CALL NO. 402
CONTRACT ID NO. 182914
ADDENDUM # 1

Subject: LEWIS-MASON-FLEMING-GREENUP COUNTIES, 121GR18M083 - FE02
Letting November 16, 2018

(1)Added - Special Notes - Pages 1-7 of 7

DRY RUN CREEK - TRIPLE 14' X 6' R.C.B.C. SHEET 1 OF 8

ARMORED EDGE DETAIL

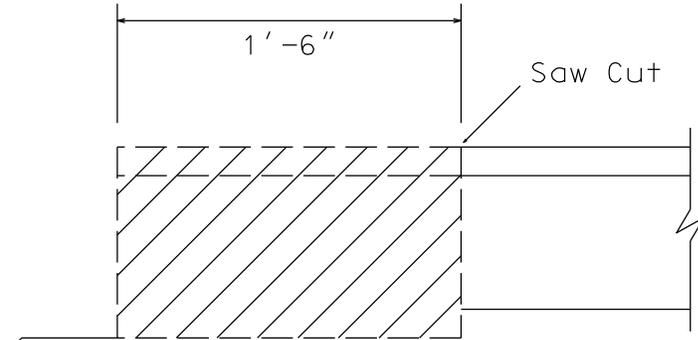
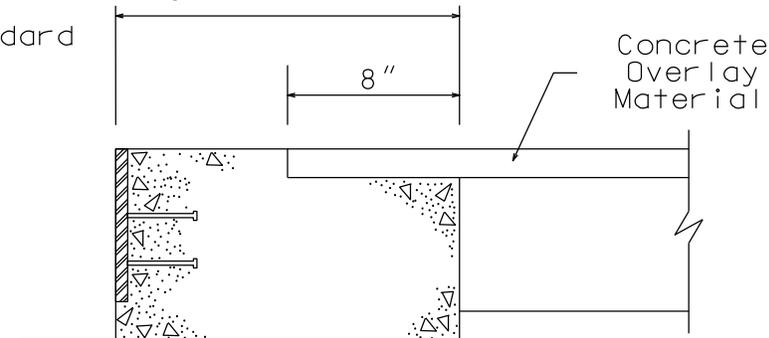
Remove X-Hatched Areas of
Concrete & Expansion Device

Pay Limits for "Armored
Edge Replacement"

See Standard
Drawing
BJE-001

ELIMINATE TRANSVERSE JOINT DETAIL

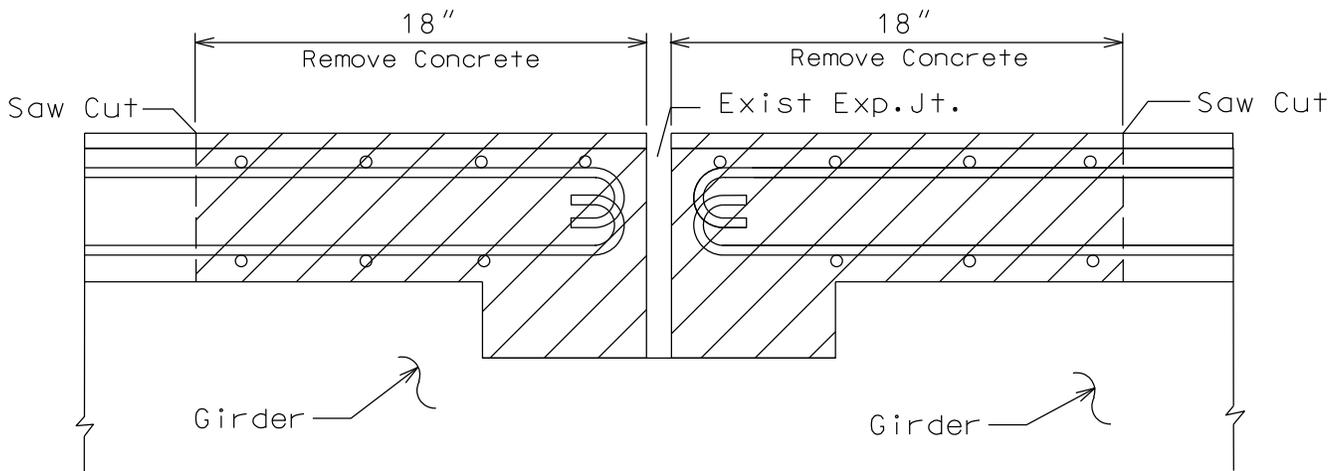
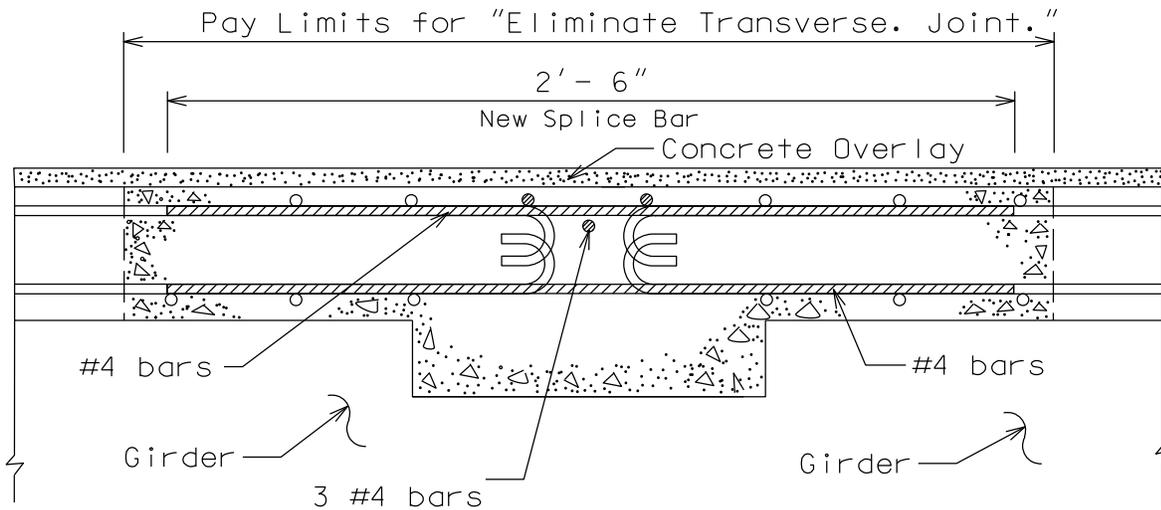
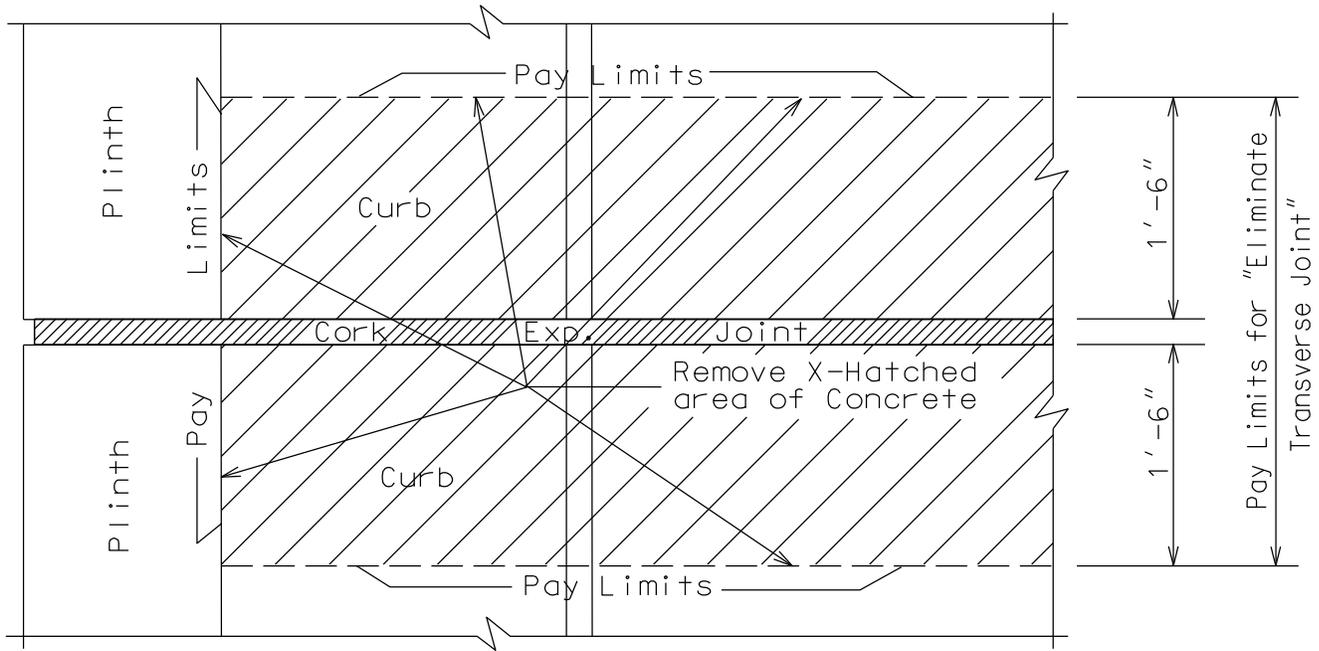
NOTE: Do not disturb existing Steel Reinforcement
